ADDENDUM NO. 11

PROJECT TITLE - PA State Police Greensburg - DNA Laboratory Facility New Building

ADDENDUM 11

MEP REVISION #1 - 11/15/2022

VERIFY SCALE		
BAR IS ONE (1) INCH LONG ON ORIGINAL DRAWING.		
IF BAR IS NOT ONE (1) INCH LONG, ADJUST SCALE ACCORDINGLY.		
DRAWN BY E HOOVER	DATE 05/24/2022	DRAWING NO. E403 (VOLUME 1 OF 1)
CHECKED BY S MULHOLLEN	SCALE 1/8" = 1'-0"

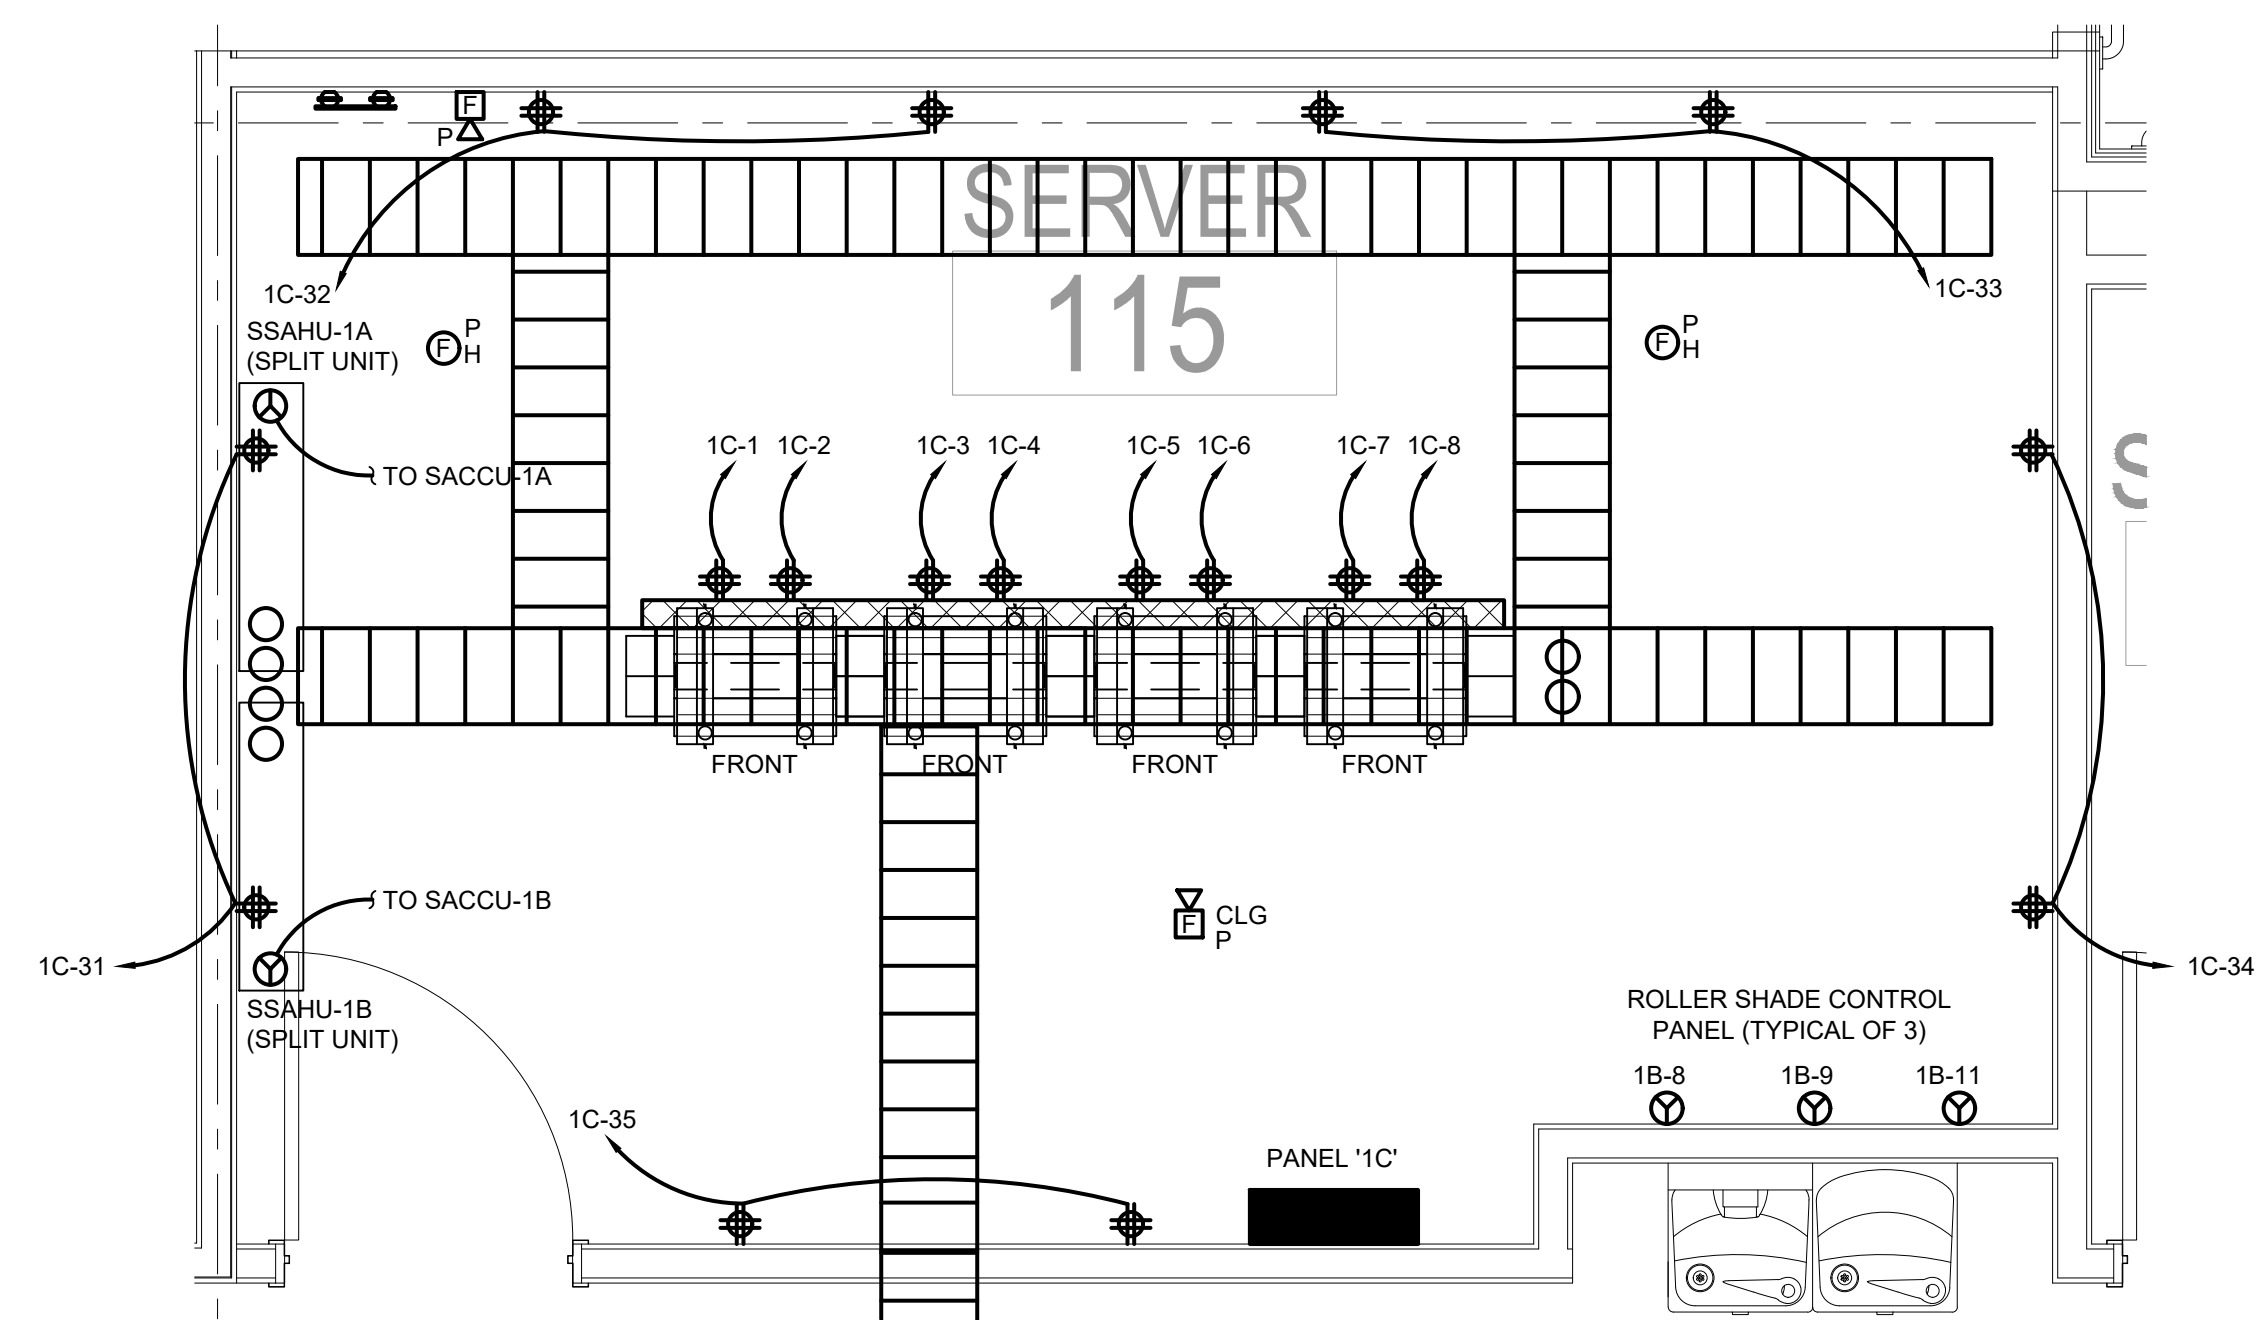
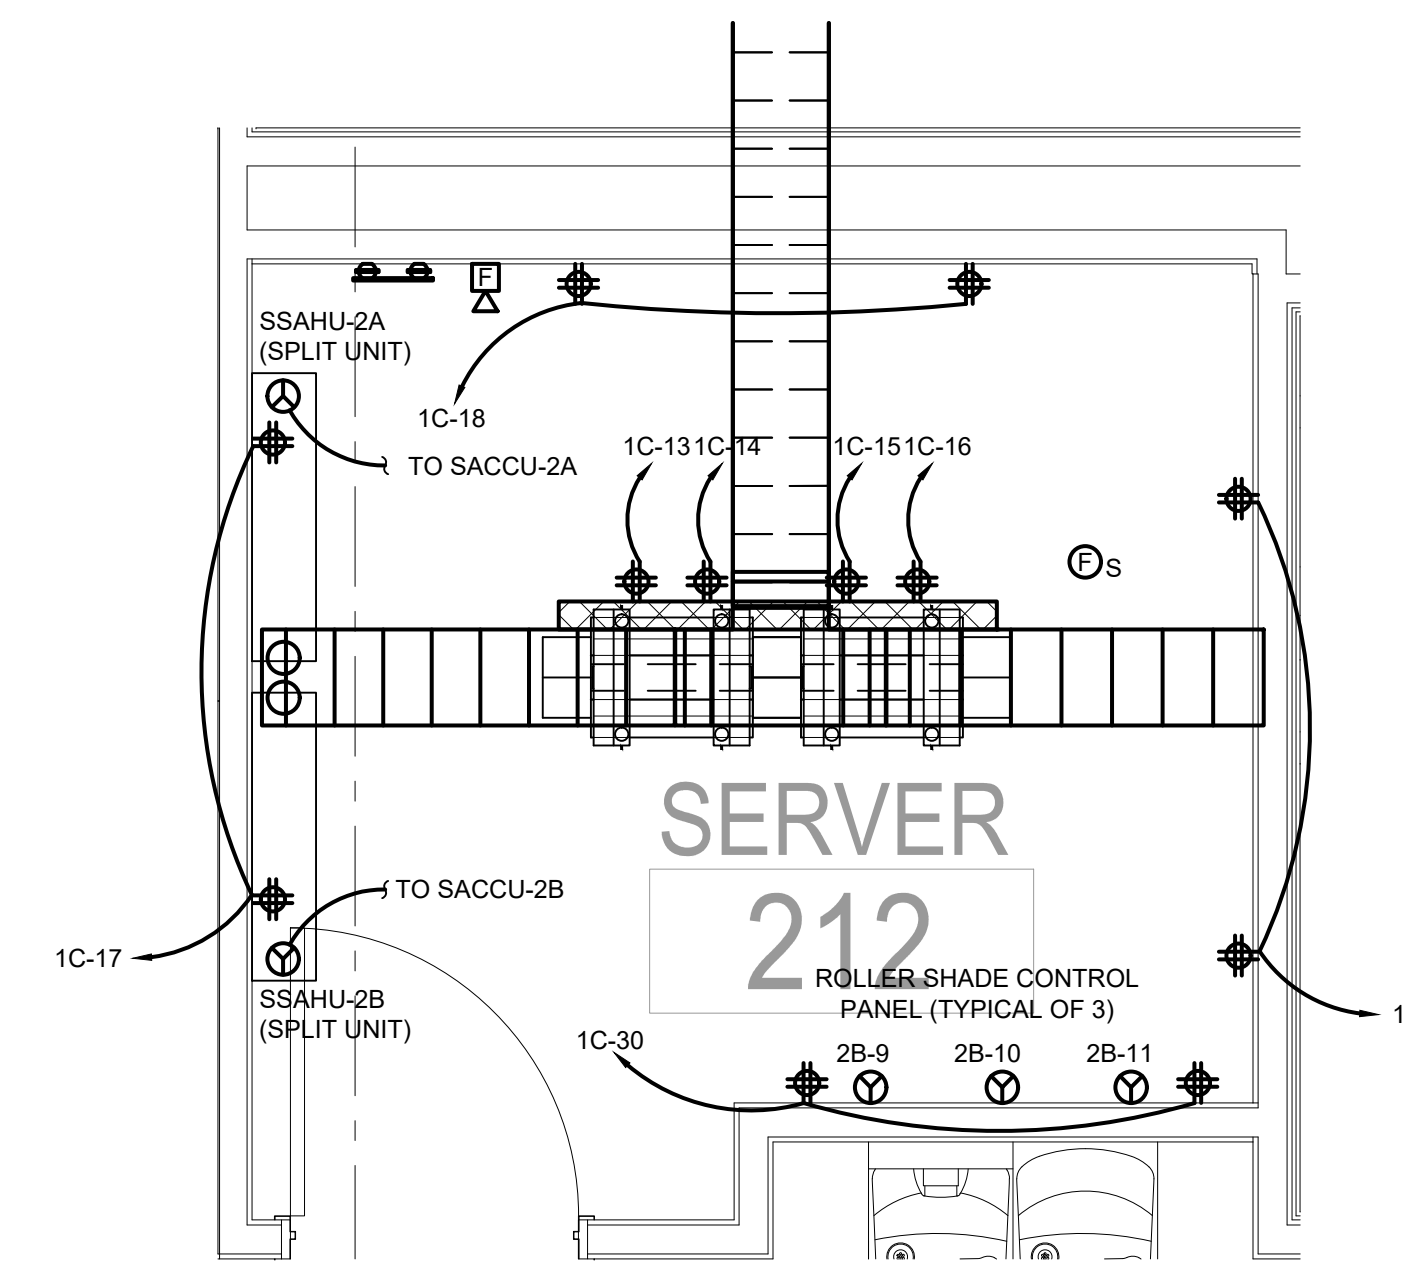
E403 - Added new sheet for enlarged Telecom Rooms with revised layouts per client agency comments.
